TECHNICAL BULLETIN

DATE: 3 APRIL 1978
PAGE 1 OF 4

INSTALLATION -- TAIL ROTOR PITCH CONTROL LINKS PN 369A1807-5

Figure 1. Replacement - Tail Rotor Link Assemblies

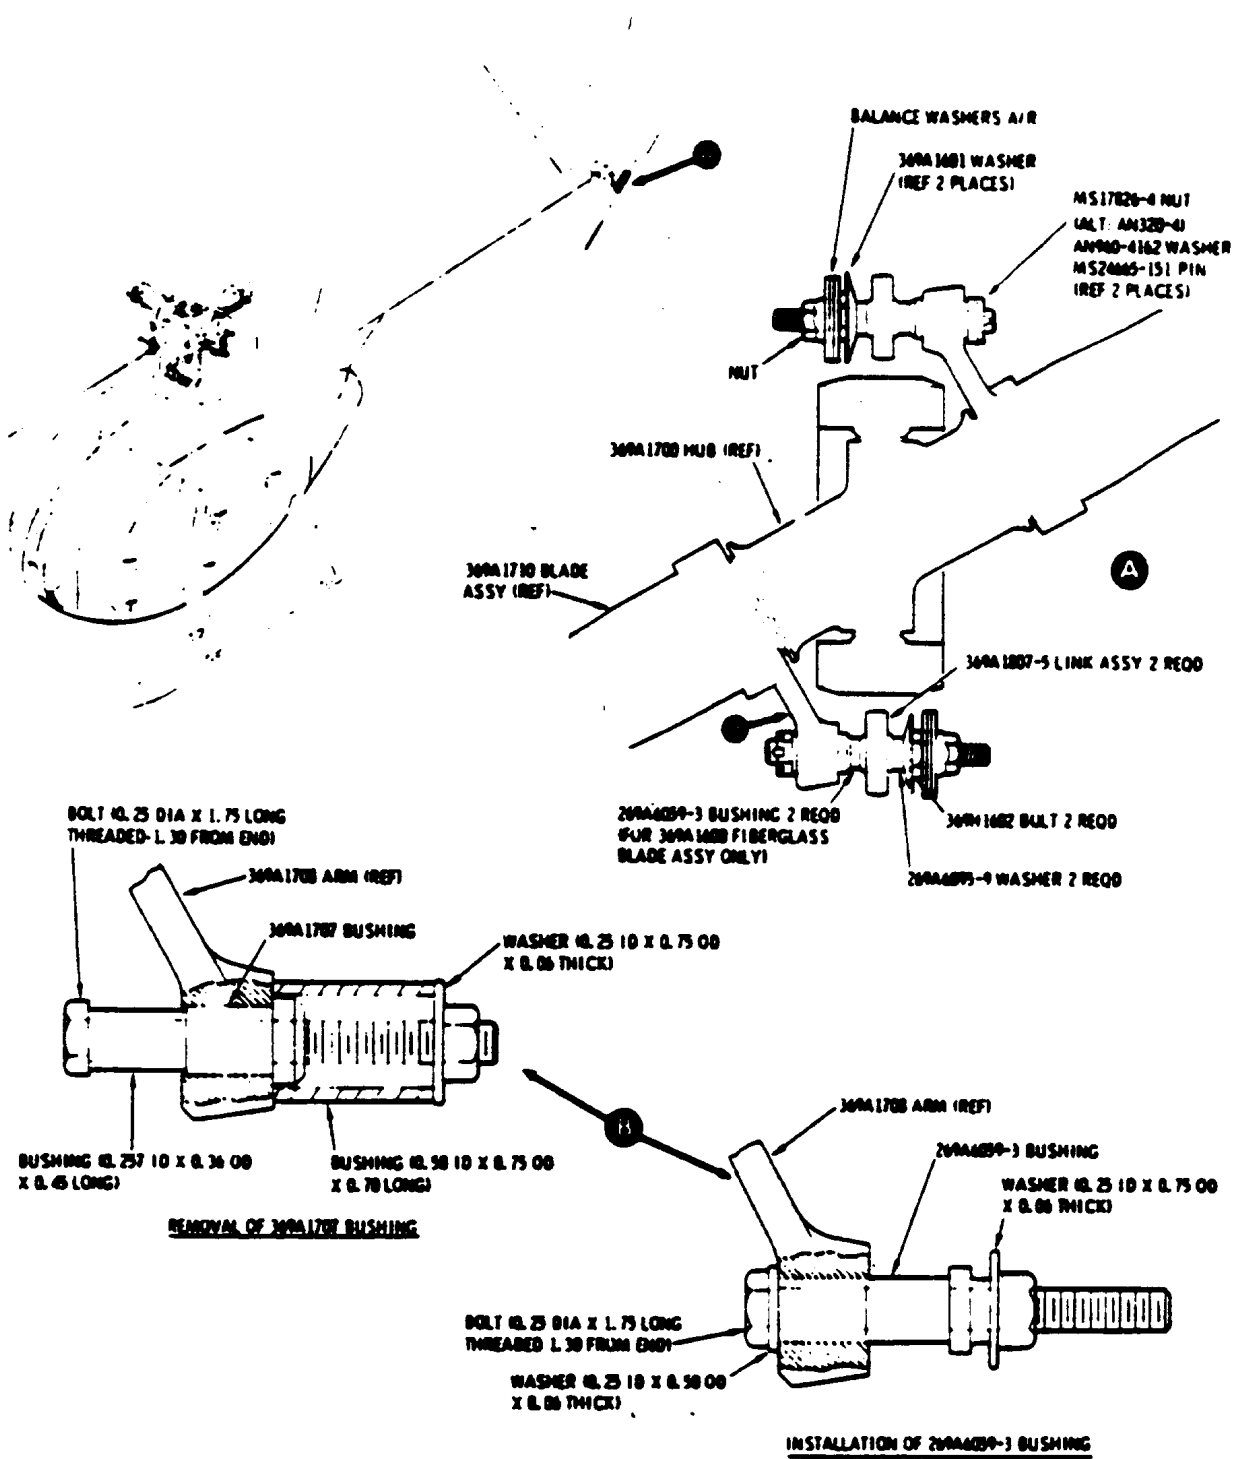
The information given in this Service Information Notice lists a procedure for removal of existing PN 369A1807 tail rotor pitch control links where installed on the above affected helicopters, and replacement with new PN 369A1807-5 pitch control link assemblies. The new -5 links incorporate new type bearings which provide increased angular throw between the link and swashplate, and the link and blade control arm, when blades are in high pitch angles.

- (3). Replace existing 369A1707 bushing in each pitch control as follows:
 - (a). Assemble bolt, bushings, washer and nut on pitch control arm as shown in Figure 1; tighten bolt to remove 369A1707 bushing
 - (b). Assemble bolt, washer, new 269A6059-3 bushing, washer and nut, as shown in Figure 1; tighten nut to seat bushing in arm. Install bushing with wet zinc chromate primer.
